ADDENDUM NO. 1

**HANOVER COMMUNITY SCHOOL CORPORATION - NEW RESOURCE
CENTER AND RELATED WORK
Cedar Lake, IN 46303**

This Addendum consists of page ADD 1-1 and attached Addendum No. 1 from Gibraltar Design dated May 27, 2021 and consisting of 5 pages and 48 drawings.

C-2.1

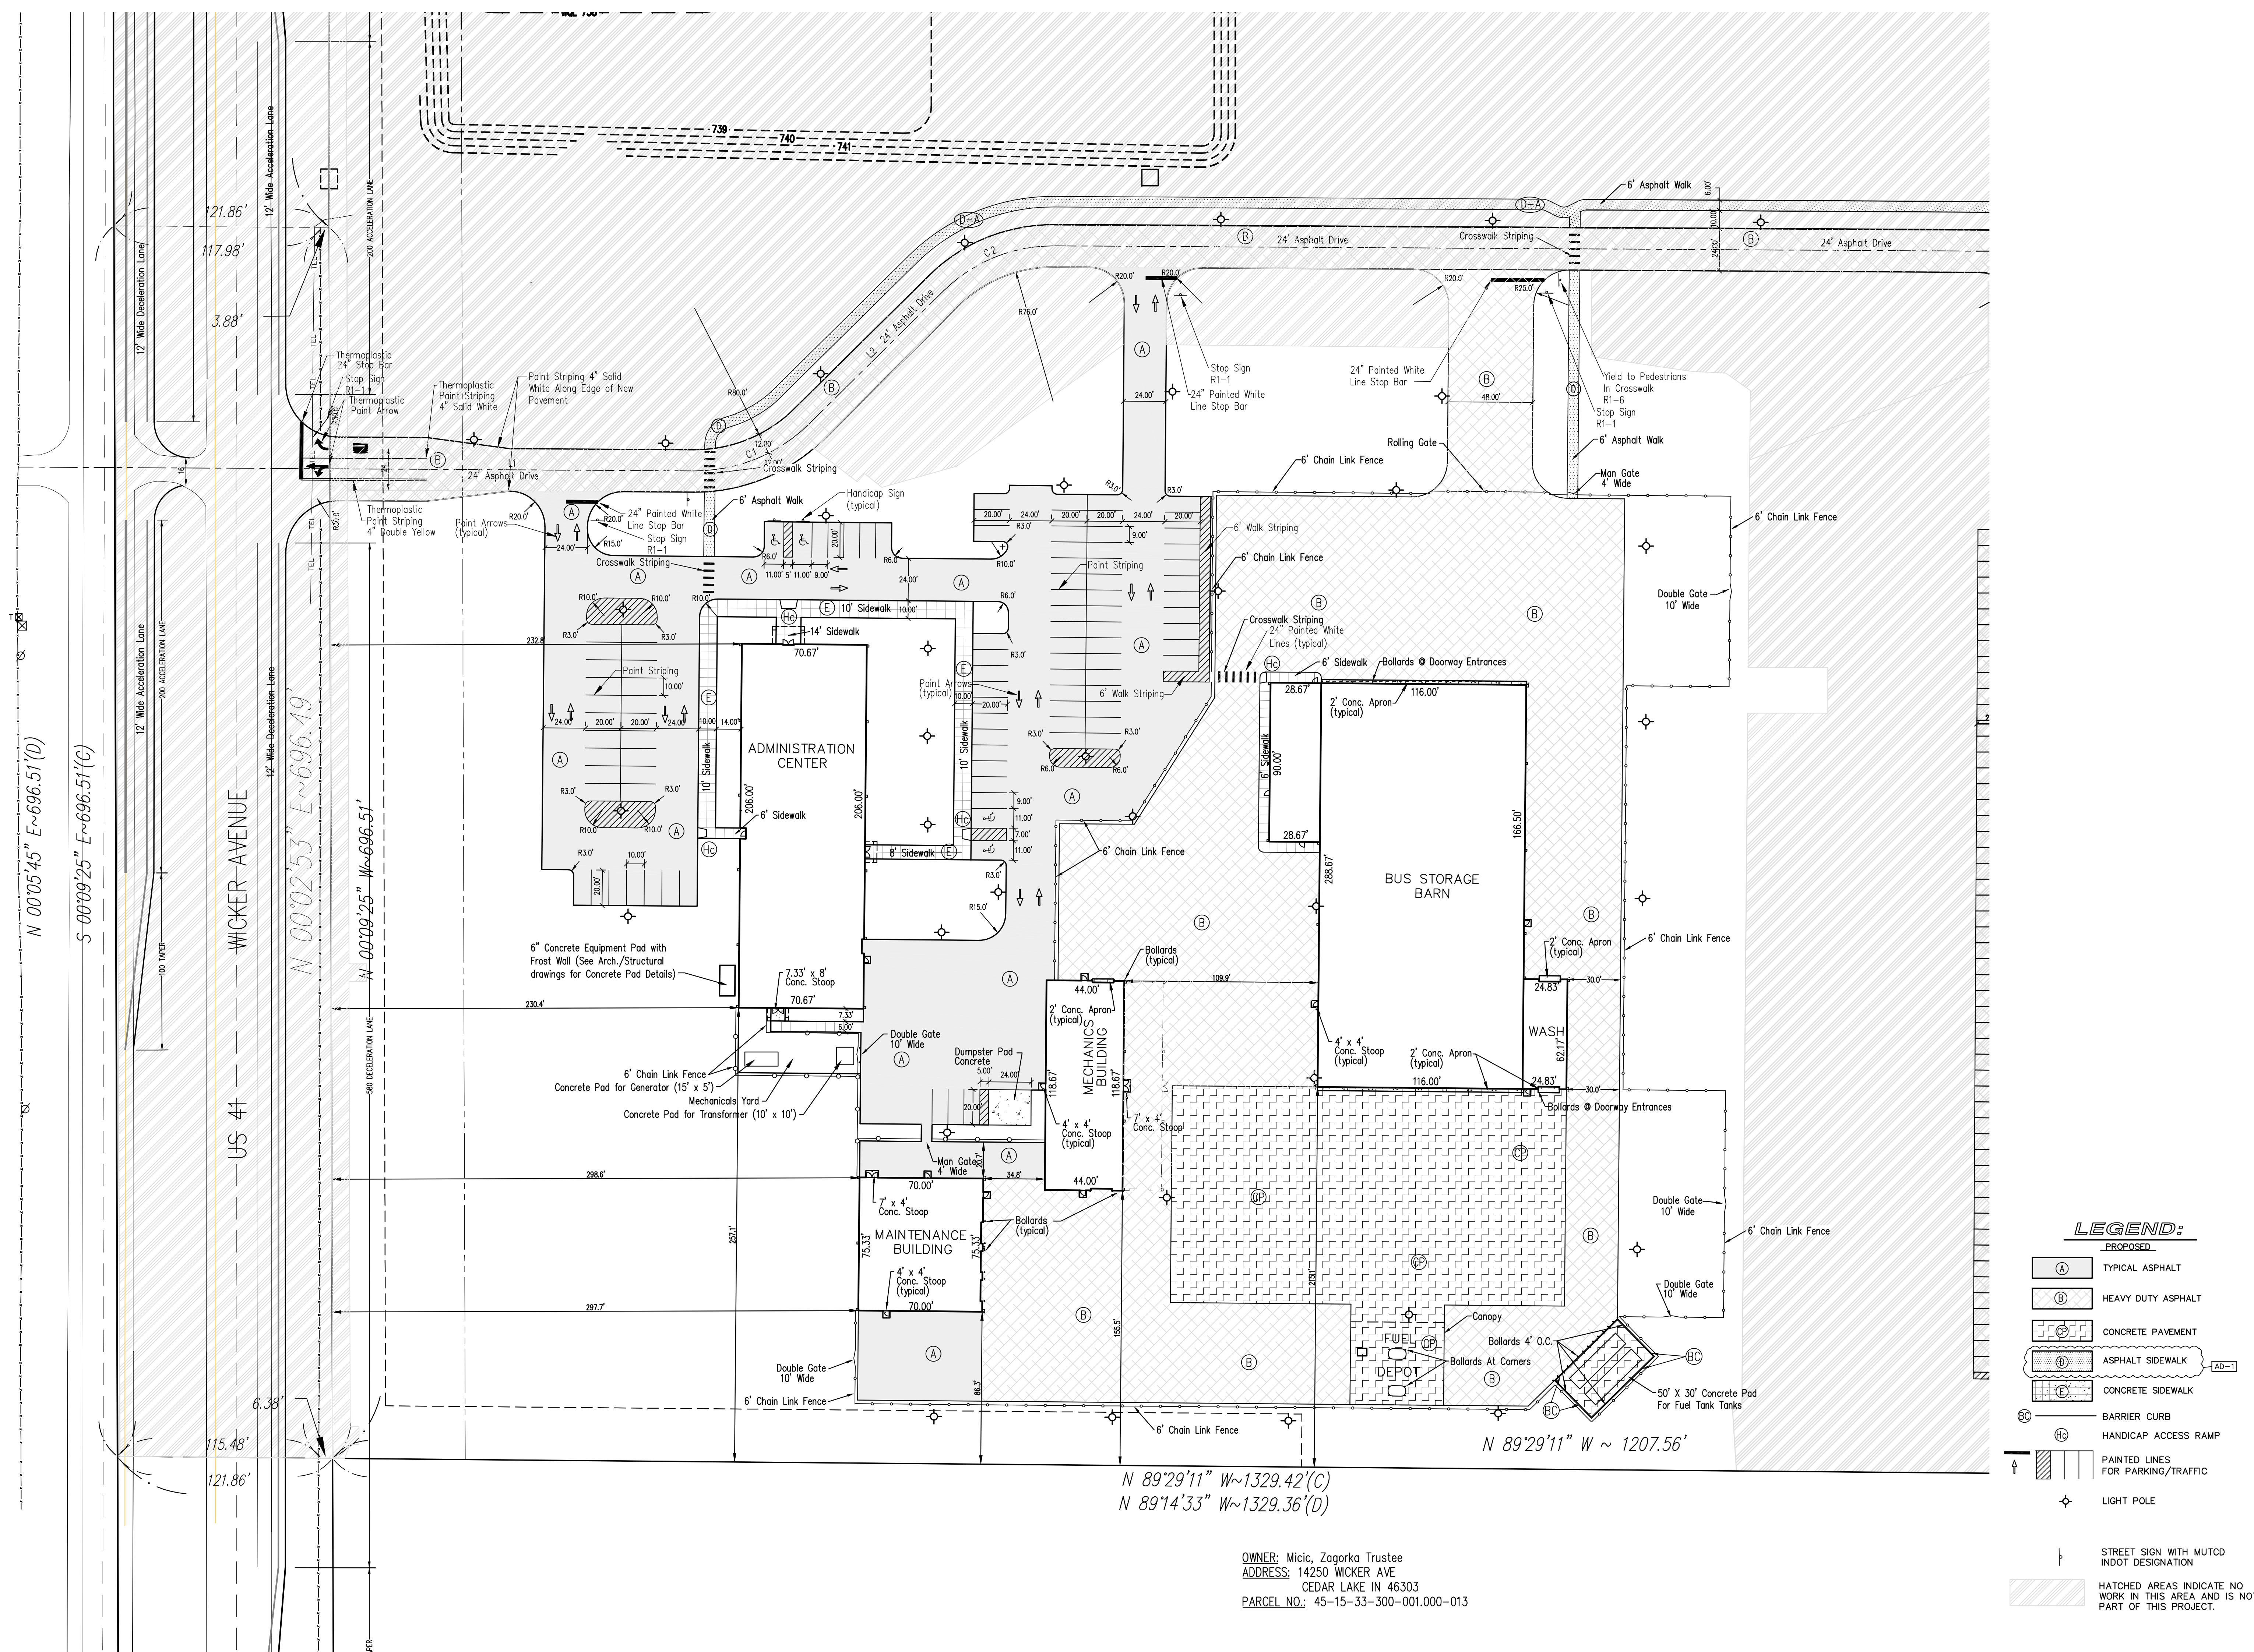
2. Sheet C-2.1

1. Proposed legend description revised to Asphalt Sidewalk.

DRAWING
**SANITARY SEWERS & WATER
MAIN PLAN**

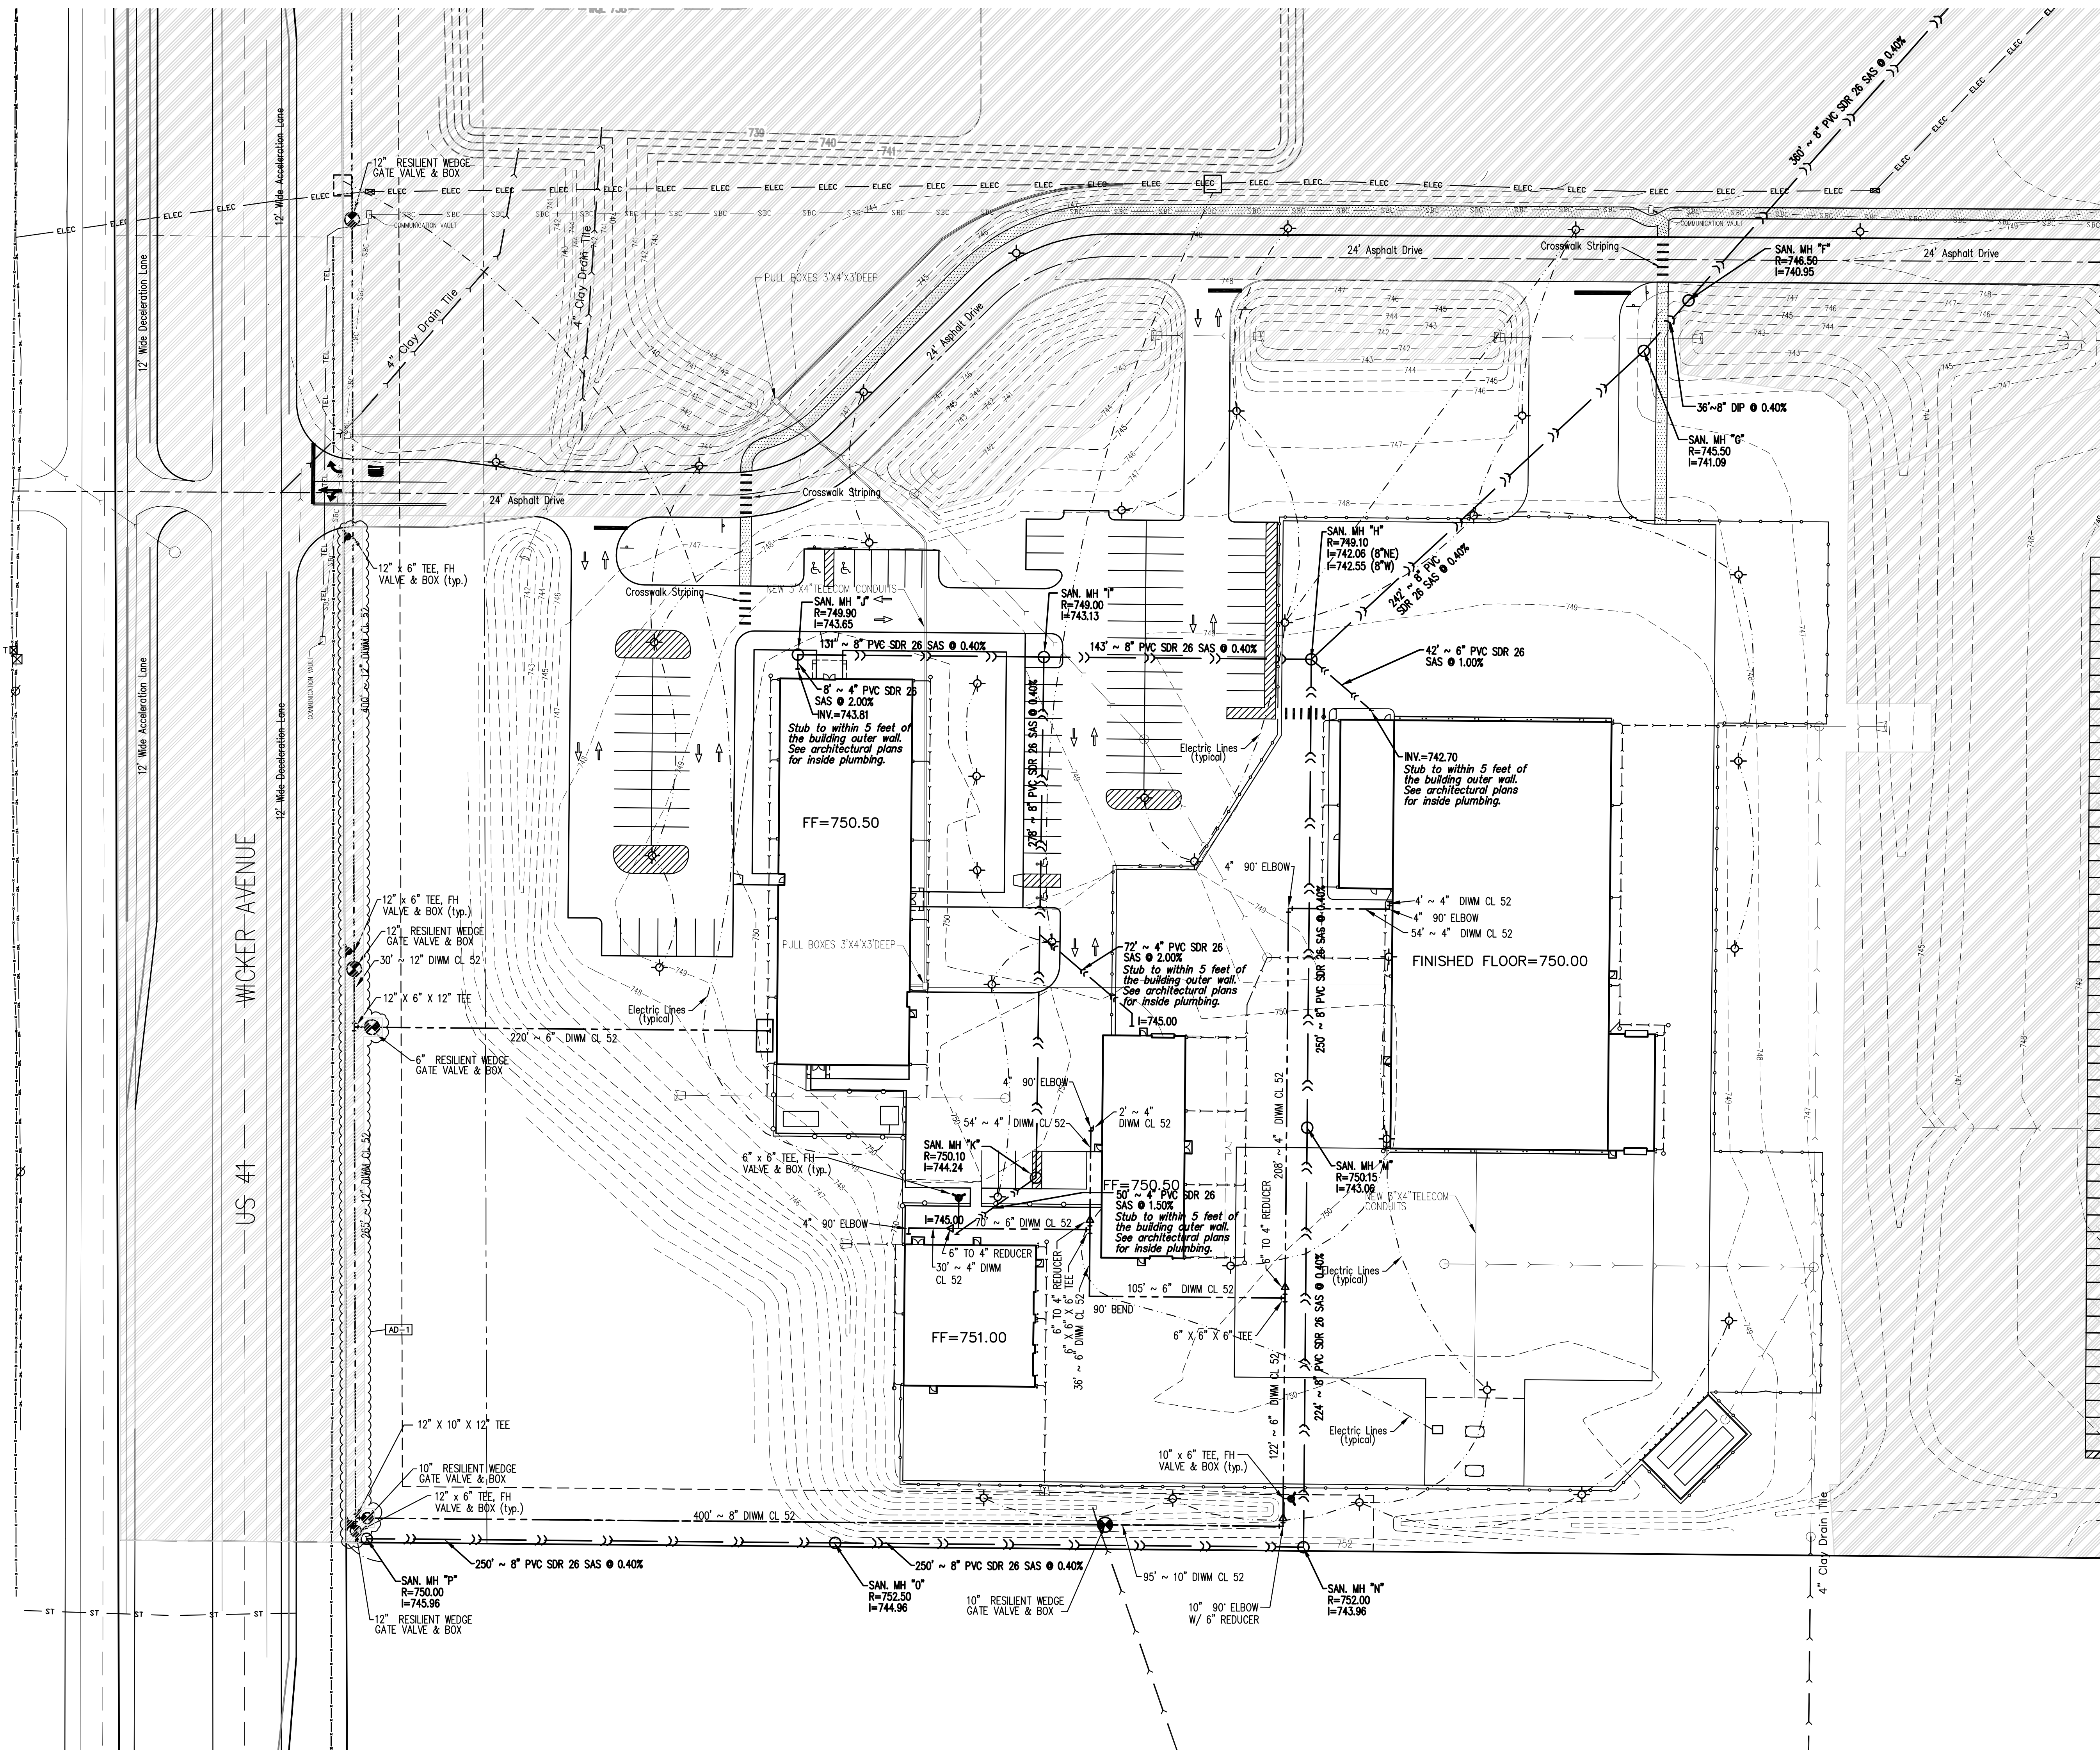
3. Sheet C-3.1

GIBRALTAR DESIGN SHEET
C-3.1

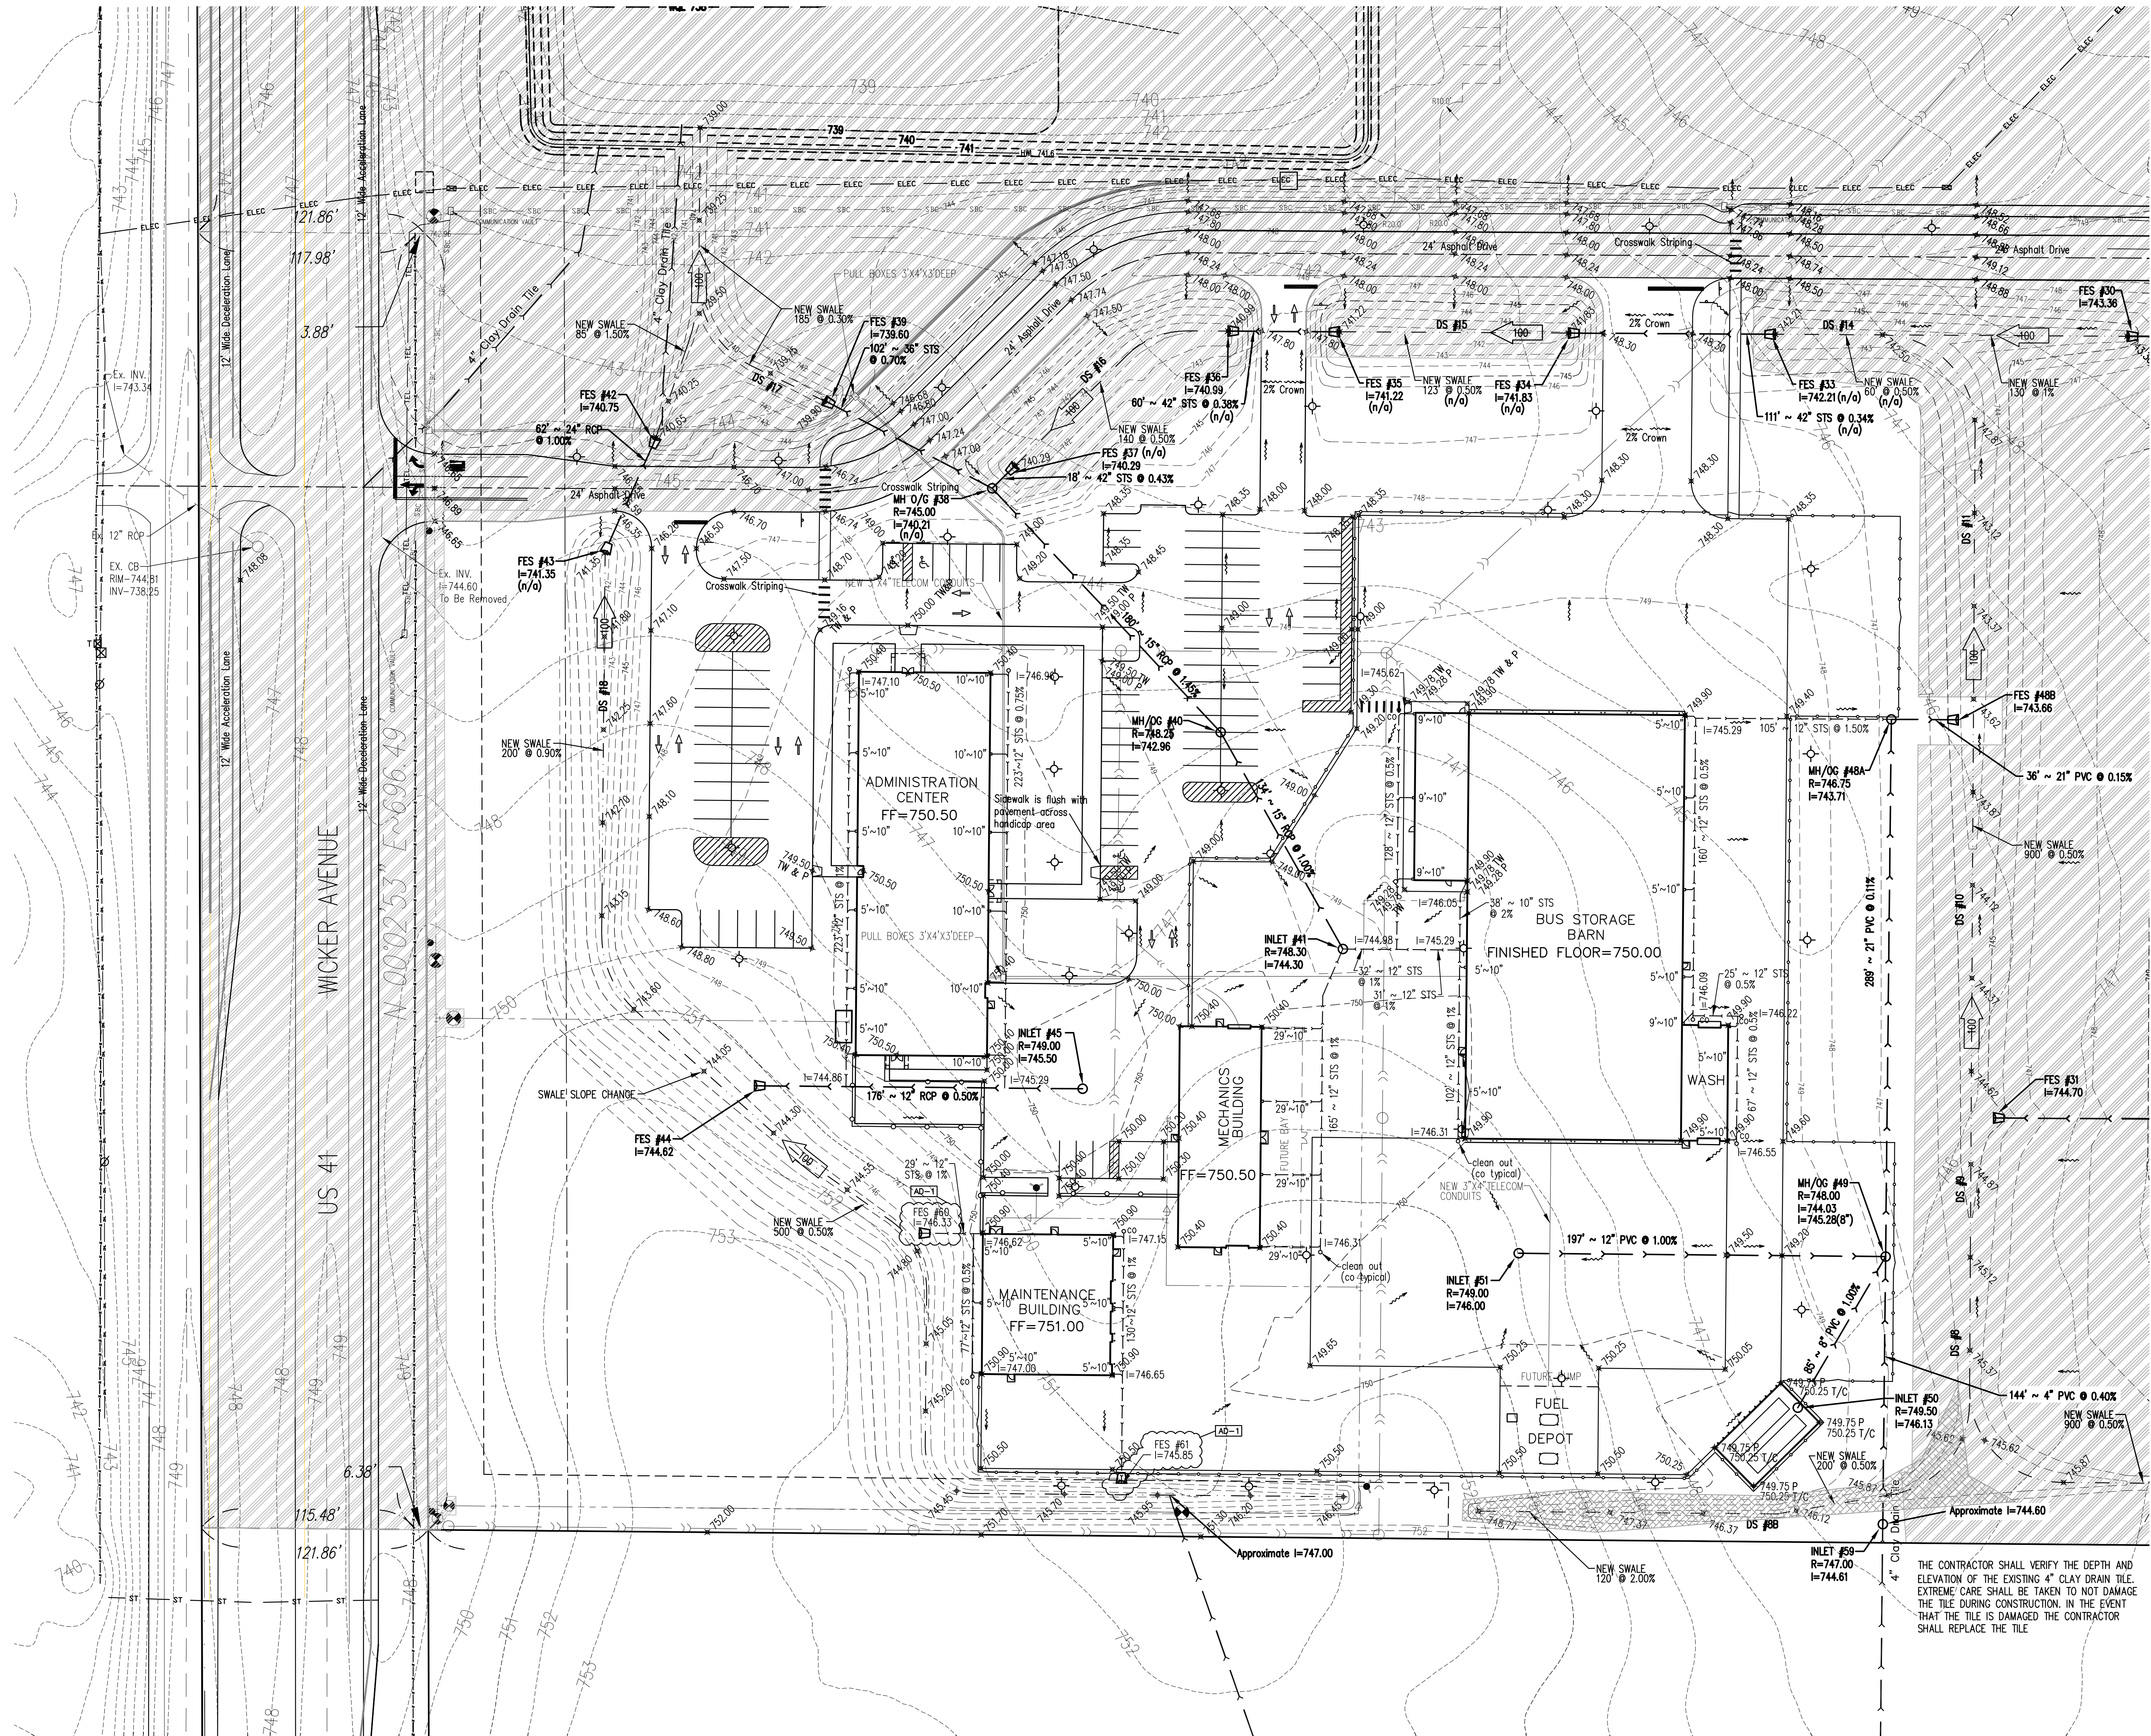
4. Sheet C-4.1

1. FES #60 and FES #61 are added near the Maintenance Building.
